Water Right Conditions  
Tracking Slip

FILE # # G-17535

**PUBLIC INTEREST REVIEW FOR GROUNDWATER APPLICATIONS**

**A. GENERAL INFORMATION:** Applicant's Name: Alkali Farms Corp/ C/O Jerry Leslie County: Gilliam

### Groundwater Application G-17535, Alkali Farms Gilliam County, Arlington & Horn Butte Quads

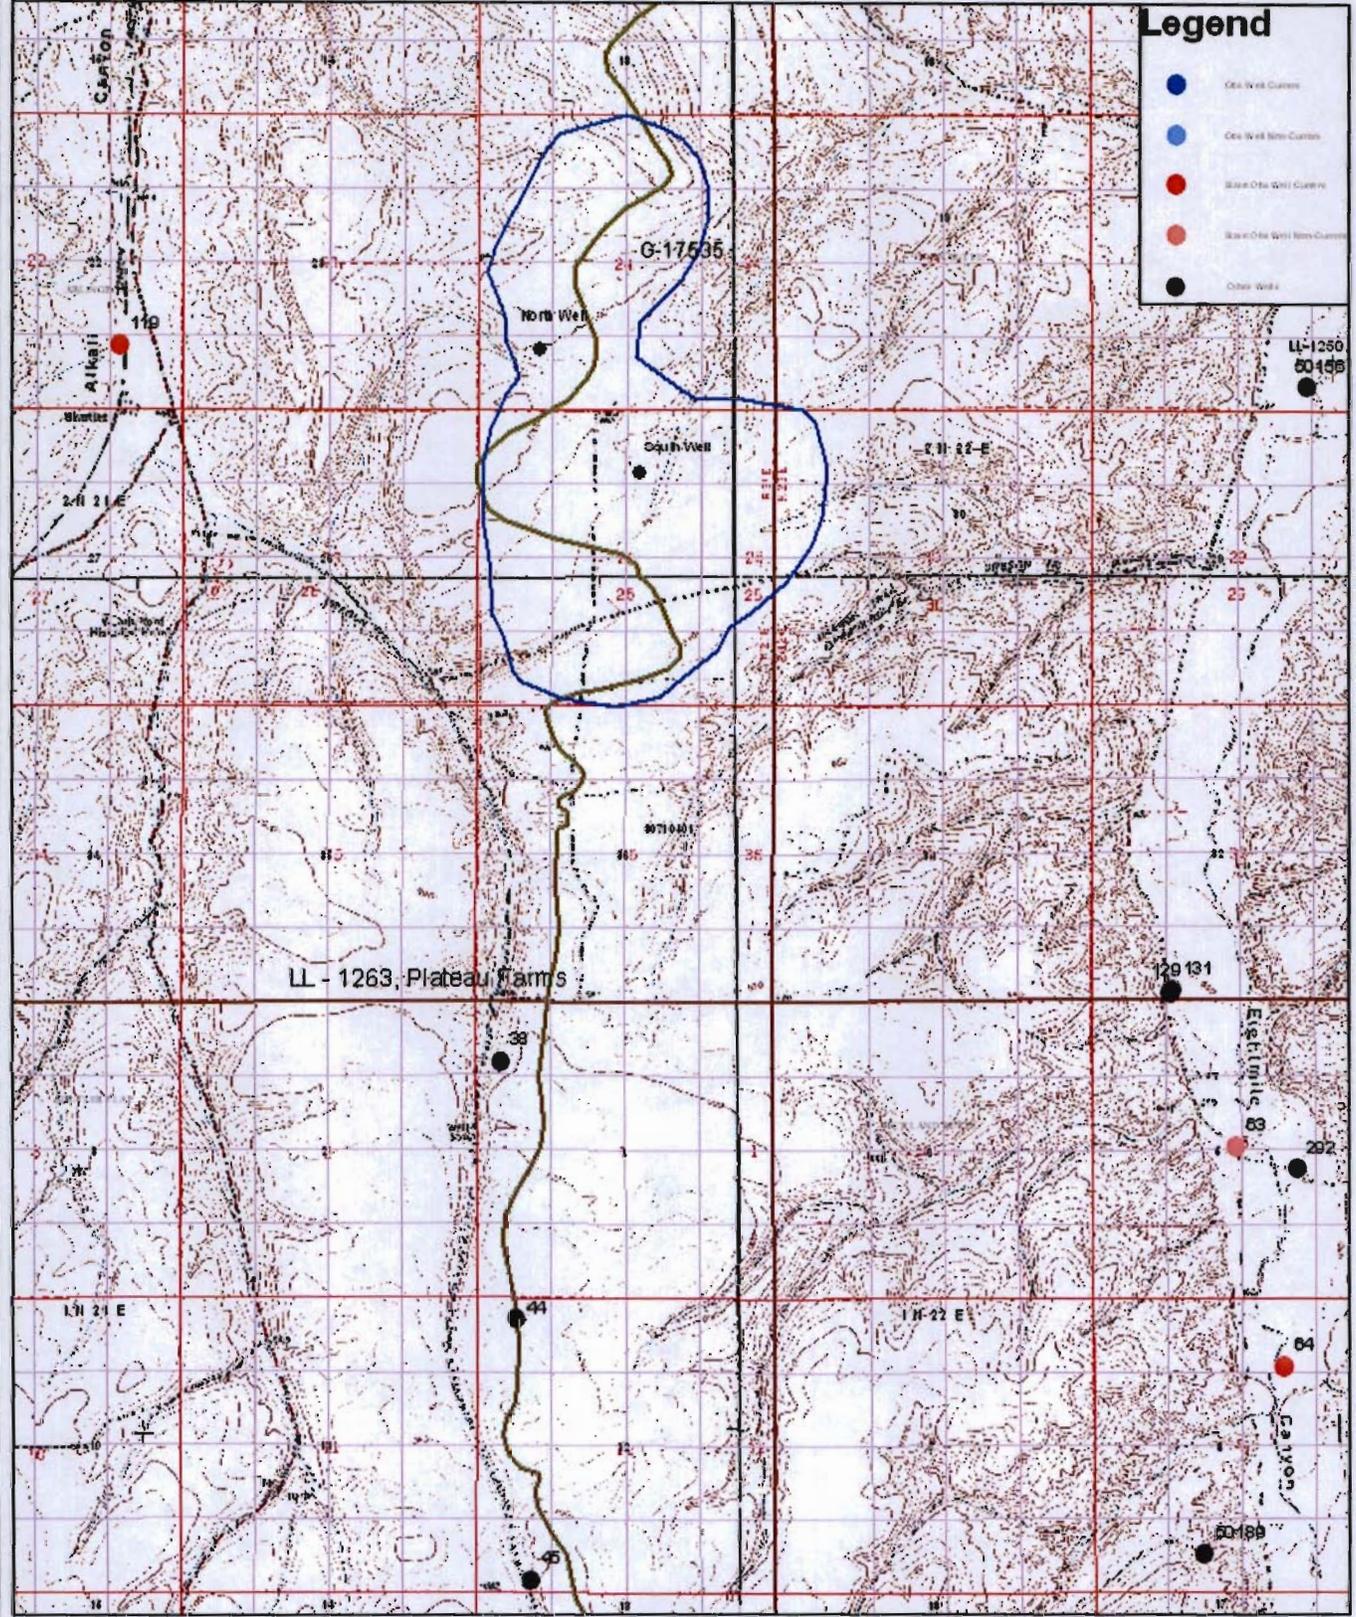
B3. Groundwater availability remarks: The proposed wells will be completed in the Columbia River Basalt Group (CRBG). Aquifers within the CRBG have shown long-term declines as a result of large scale development. There are two wells near the proposed development: GILL 64 and GILL 119. The location of the wells in relation to the proposed development is shown on the map. The water level has declined over 110 feet in GILL 64 from 1955 to 2011. At GILL 119, the water level has declined 27 feet from 1984 to 2011.

- i.  The permit should contain condition #(s) 7B – Interference, 7N - Annual WL (February/March), 7P – Well Tag, 7T – Measuring Tube, Large measuring and reporting with flow meter on each well;
